City of
Melville

DEVELOPMENT ADVISORY UNIT MEETING

UP26/106 Grouped Dwelling at Lot 71 (No. 51) Ogilvie Road, Mount Pleasant

Ward	Applecross - Mount Pleasant Ward
Category	Operational
File Number:	
Responsible Officer:	Manager Development Approvals
Voting Requirements:	Simple Majority
Officer Disclosure of Interest:	Nil
Application Number:	DA-2025-104
Applicant:	Lta Architects

Figure 1. Proposed Site Plan with North being top of image (Source: Application)

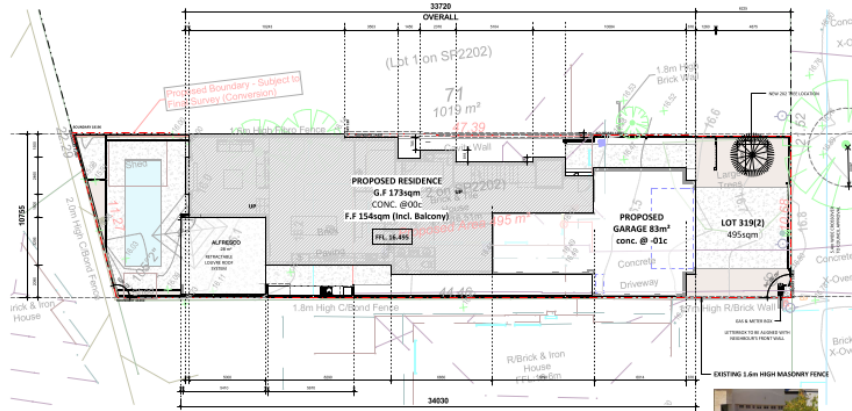
- Amended plans showing the proposed development fully contained within the subject site's boundaries;
- Amendments to the northern boundary wall to meet the deemed-to-comply criteria in the R-Codes; and
- Amendments to the lot boundary setbacks along the southern boundary to meet the deemed-to-comply criteria in the R-Codes; and

- Amended plans reducing overshadowing from 42.2% to 40.3% by lowering the height of the alfresco boundary wall from 3m to 2.4m, thus reducing impacts on their north facing patio and meals major opening.

Figure 3. Overshadowing measurement from subject site onto southern property

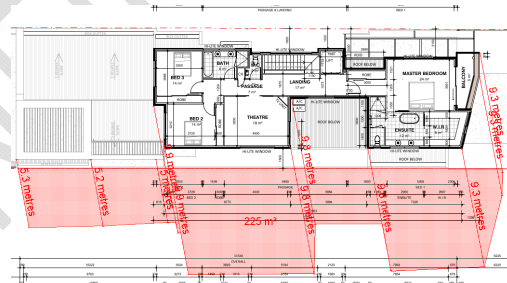
Design Principles:	Assessment:
<p>P2.1: <i>Effective solar access for the proposed development and protection of the solar access.</i></p> <p>P2.2: <i>Development designed to protect solar access for neighbouring properties taking account the potential to overshadow existing:</i></p> <ul style="list-style-type: none"> • <i>outdoor living areas;</i> • <i>north facing major openings to habitable rooms, within 15 degrees of north in each direction; or</i> • <i>roof mounted solar collectors.</i> 	<ul style="list-style-type: none"> • The lot boundary setbacks of the dwelling and the location of the outdoor living area will ensure the proposed development is capable of achieving adequate solar access. • When considering the proposed overshadowing, it is important to note that both the subject site and No. 53 Ogilvie Road are narrow lots with east to west orientations. As a result, overshadowing to the south of the subject site is unavoidable as can commonly be seen on similar lots of this nature. The impact of the proposed overshadowing therefore needs to be assessed on its merits in accordance with the applicable design principles. • The proposed development meets the deemed-to-comply building height requirements of LPP1.9 and southern lot boundary setback requirements of the R-Codes. While discretion is required in relation to the open space provided, this is considered minor and consistent with the applicable design principles. The proposed development is therefore not considered to be an overdesign noting that the plans have gone through numerous revisions to better align with the applicable frameworks, with the overshadowing specifically being reduced by the applicant from 42.2% to 40.3% by lowering the height of the alfresco boundary wall from 3m to 2.4m.

Figure 4. Aerial photograph showing No. 53 Ogilvie Road to the south of subject site with northern patio circled in red

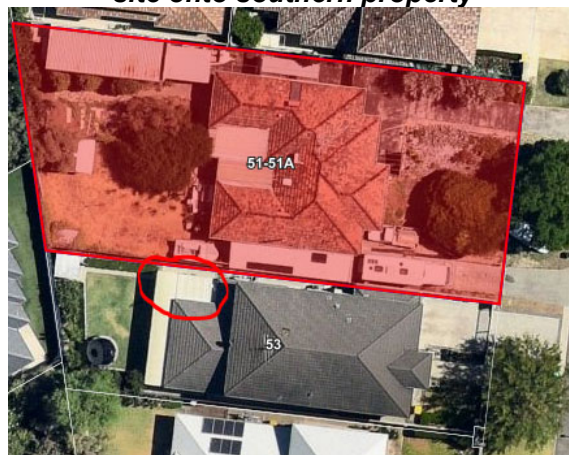
- It is noted that No. 53 Ogilvie Road has a north facing patio that will be impacted by the proposed overshadowing as can be seen in Figures 4 and 5 below. However, the outdoor living area for the dwelling is located further to the south. Nonetheless, this northern patio will still be capable of receiving sunlight from the northwest therefore minimising the impacts from the proposed overshadowing which has specifically been reduced in this area by lowering the height of the alfresco boundary wall from 3m to 2.4m. The original southern alfresco will not be impacted by the proposed overshadowing and will also be capable of receiving northwestern solar access.

- No. 53 Ogilvie Road does not have any roof mounted solar collectors that will be impacted by the proposed overshadowing as can be seen in the Figure 4.
